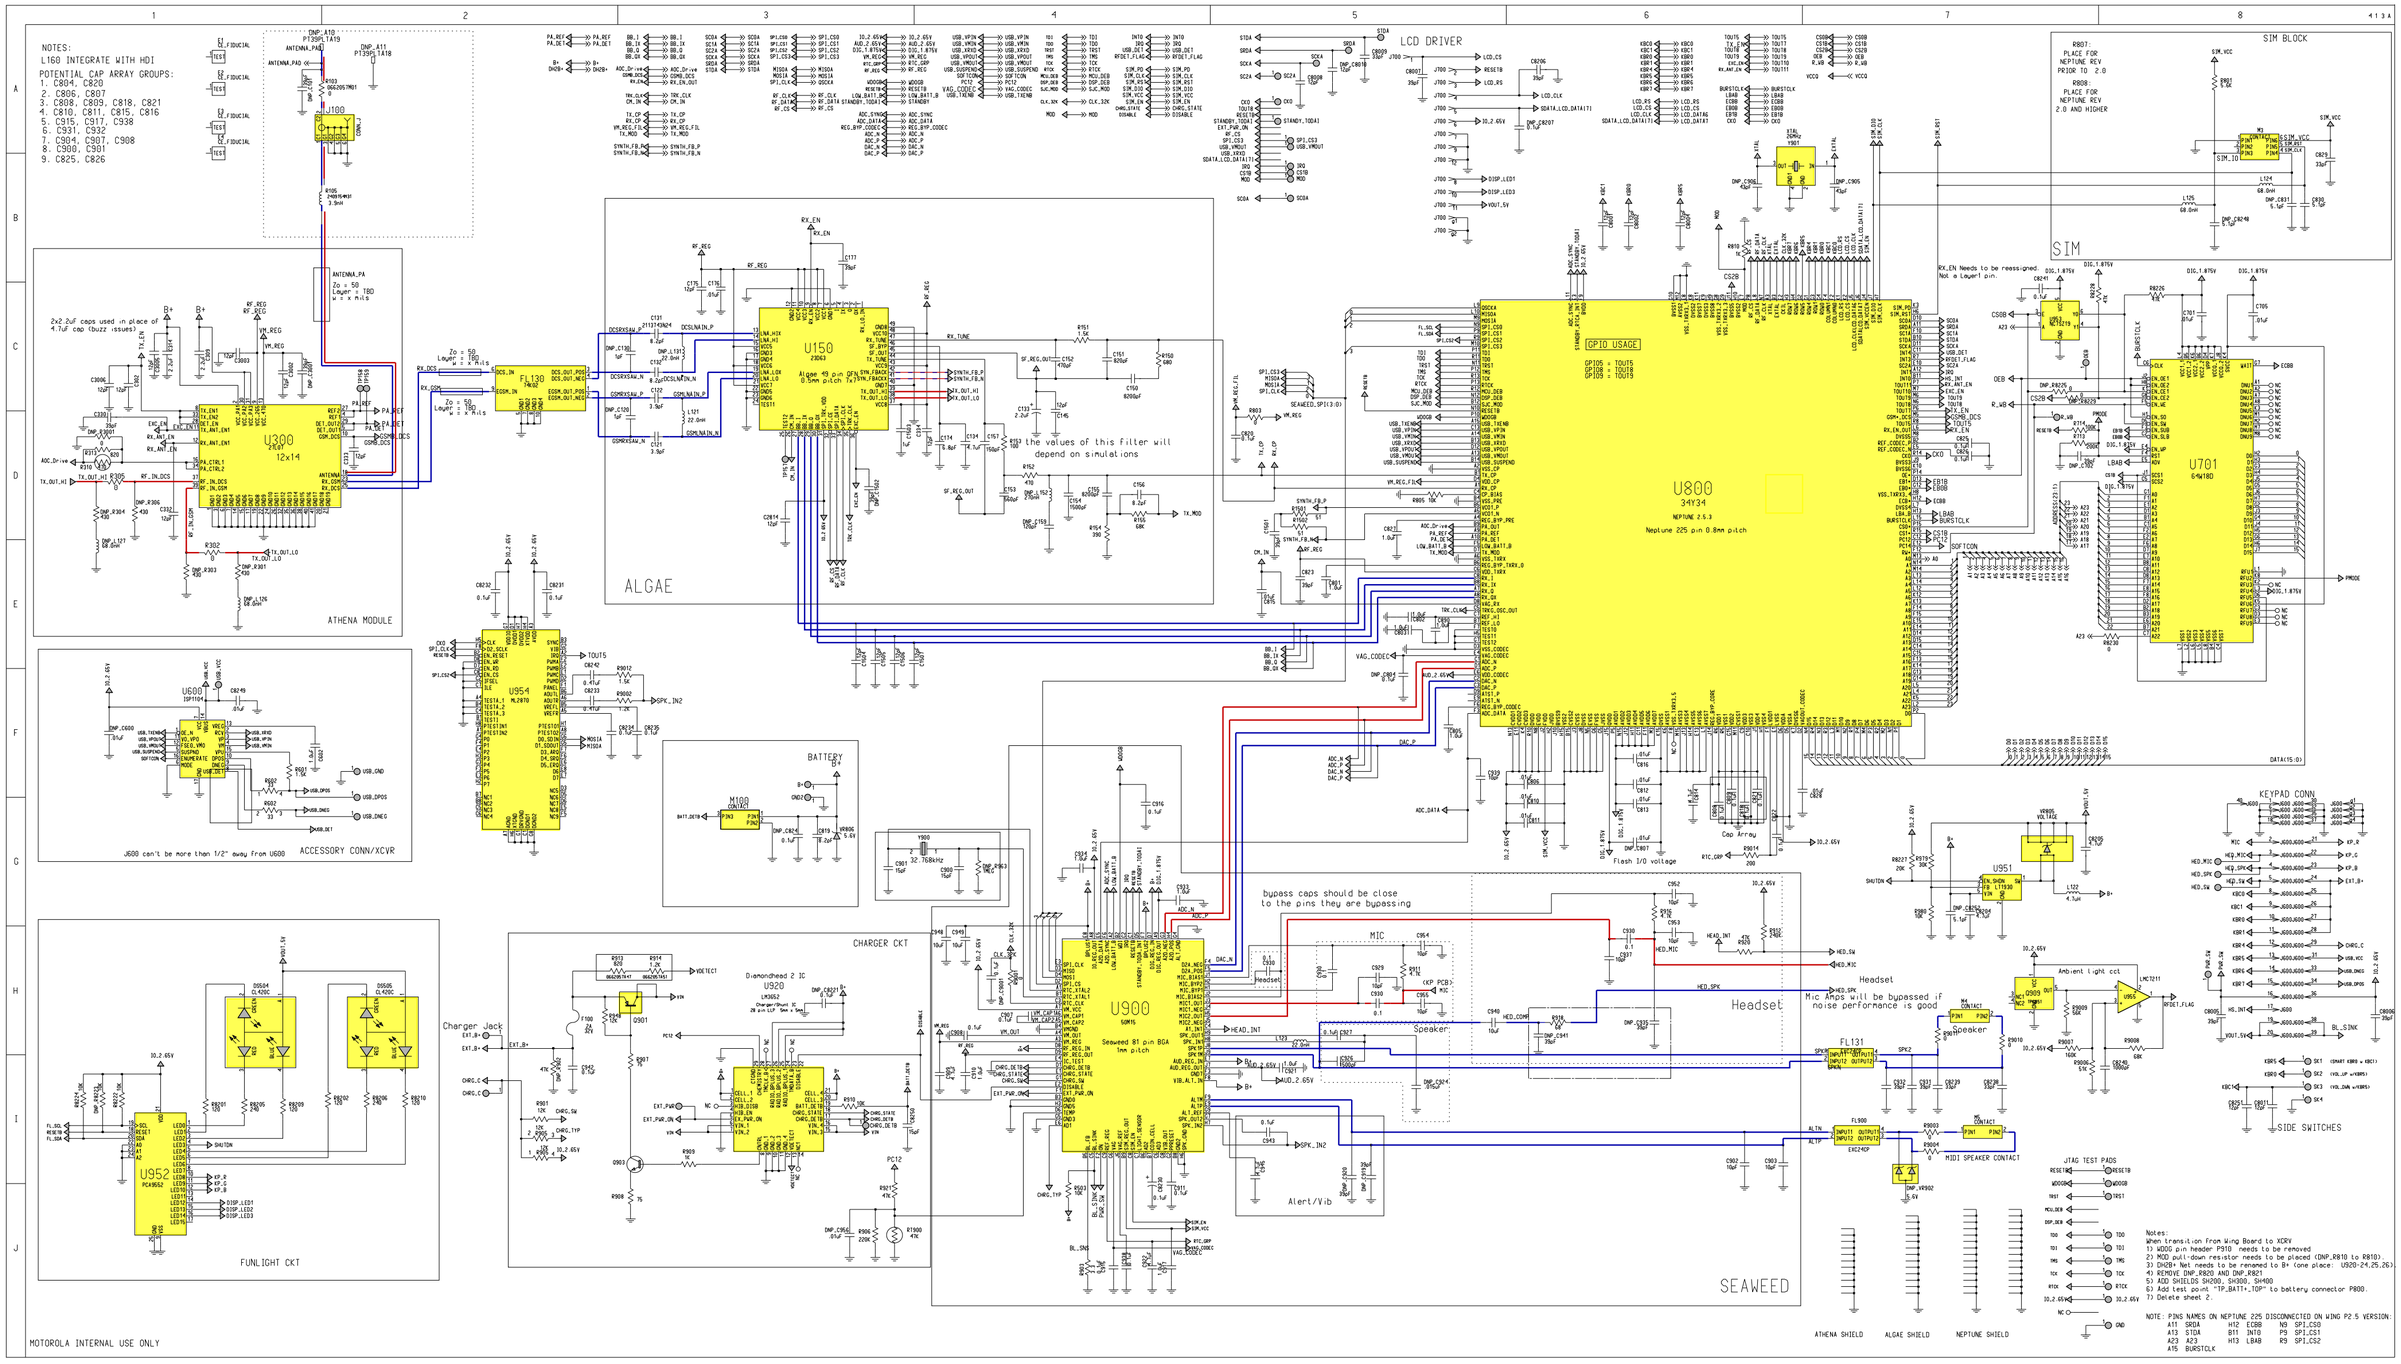
Notes:
When transition from Wing Board to XCRV
1) WDOG pin header P910 needs to be removed
2) MOD pull-down resistor needs to be placed (DNP_R810 to R810).
3) DVDD+ Net needs to be renamed to B+ (one place: U920-24,25,26)
4) REMOVE DNP_R820 AND DNP_R821
5) ADD SHIELDS SH300, SH900, SH400
6) Add test point "TP_BATT+_TOP" to battery connector P800.
7) Delete sheet 2.
